24 March 2020

Anthony Ko
Team Leader, Energy Assessments
Department of Planning, Industry and Environment
4 Parramatta Square, 12 Darcy Street
Parramatta NSW 2150

Re: Snowy 2.0 Main Works - Preferred Infrastructure Report - Response to request

Snowy 2.0
Preferred infrastructure report
and response to submissions
Main Works
Figure 5.1

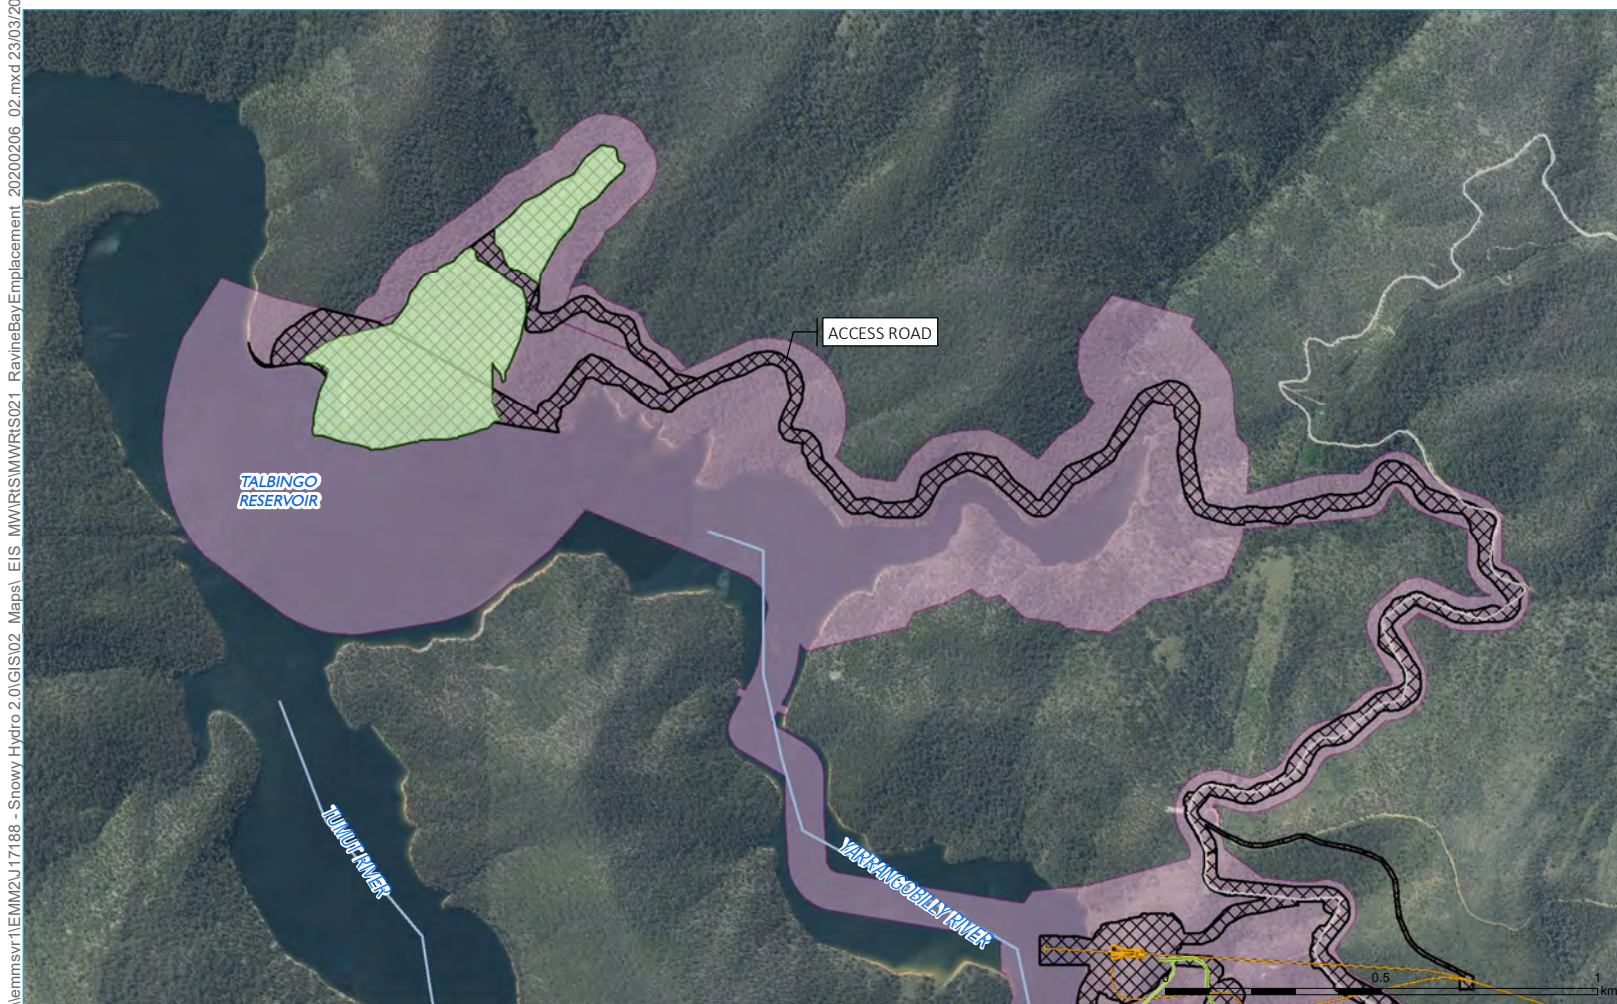
We will need updated mapping for the disturbance footprints proposed within Talbingo Reservoir. The text describes a 3ha disturbance footprint for Ravine Bay Spoil emplacement and 1 ha for the intakes, but the maps show a footprint in the order of 40+ ha at Ravine Bay.

Could you also let me know what the disturbance footprint in Tantangara Reservoir (two numbers would be helpful) one within FSL and the other within MOL.

As described in Section 3.2.2 of the PIR-RTS the excavated rock management strategy was revised including changes to the design of the excavated rock emplacement areas. The disturbance area at Ravine Bay has been subsequently refined to reflect the revised Ravine Bay emplacement area. The revised disturbance area at Ravine Bay is provided in Figure 5.1 below. This change results in a significant reduction approximately of 43 ha to the disturbance area at Ravine Bay.

The revised disturbance area will result in an in-reservoir disturbance area of approximately 2.7 ha at the Ravine Bay emplacement area and approximately 0.7 ha at the Talbingo intake. This represents a reduction of the cumulative emplacement area footprint within Talbingo Reservoir compared to the Exploratory Works which originally proposed up to approximately 59 ha total subaqueous rock placement area at Ravine Bay, Plain Creek Bay and Cascade Bay.

This also results in a change to the overall Main Works disturbance area reducing it from 640 ha to 597 ha. A revised summary of disturbance area reduction by zone is provided in Table 5.1 below.
